Bicycle & Pedestrian Advisory Commission

TO: Steven Medlin, Director, Planning Department, City & County of Durham
FROM: Durham Bicycle and Pedestrian Advisory Commission (BPAC)
RE: Bike Lane Widths along the Westpoint on 751 Development (Z0800031)

Wide Outside Lanes and Curb/Gutter- Westpoint at 751

Figure A

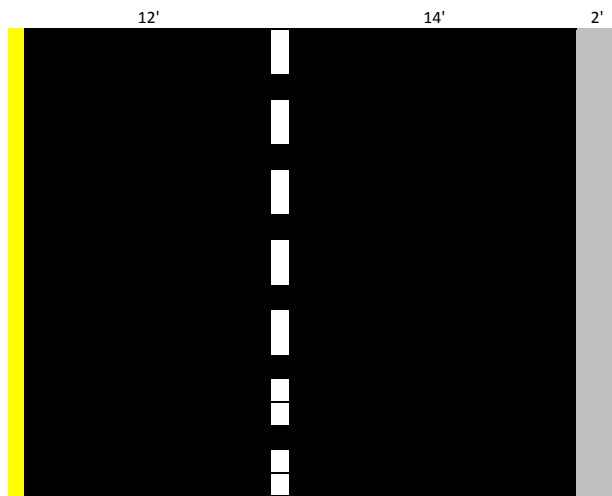
We fear that were this project allowed to proceed with accommodations only for 14 foot wide outside lanes (Figure A in the attached diagram) rather than accommodations for the full width for future bike lanes (Figure B), it will be difficult and expensive to move the associated curb & gutter at that time when local or state government is prepared to build bike lanes along NC751. As shown in the diagram, the curb and gutter would have to be moved approximately 2 feet in order to meet NCDOT minimum requirements for a bicycle lane. Due to the considerable expense to taxpayers, we believe it is unlikely that the curb would ever be moved two feet in order to provide bike lanes along this corridor.

Not recommended for this section of NC751 (LRTP, Bike Plan)

In order to install bike lanes on a road with wide outside lanes, the curb and gutter would have to be moved ~2 feet.

Figure B

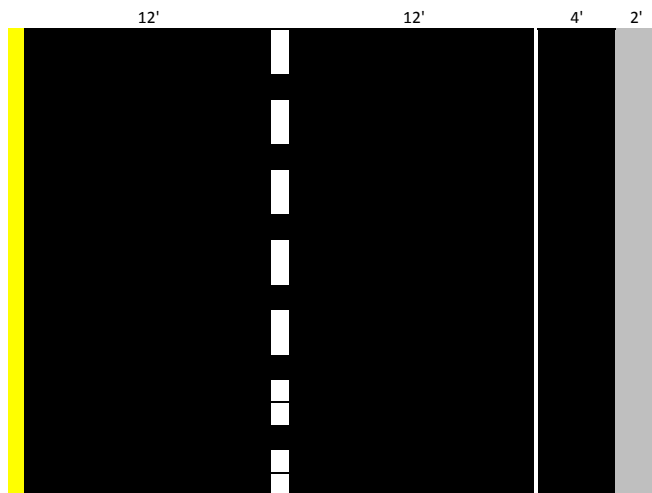
Recommended for this section of NC751 (LRTP, Bike Plan)

For these reasons, the Bicycle and Pedestrian Advisory Commission believes the community will not be well-served by this project if it does not include bicycle lanes or appropriate width to accommodate bicycle lanes in the future and recommends that the rezoning request be denied without such accommodations.
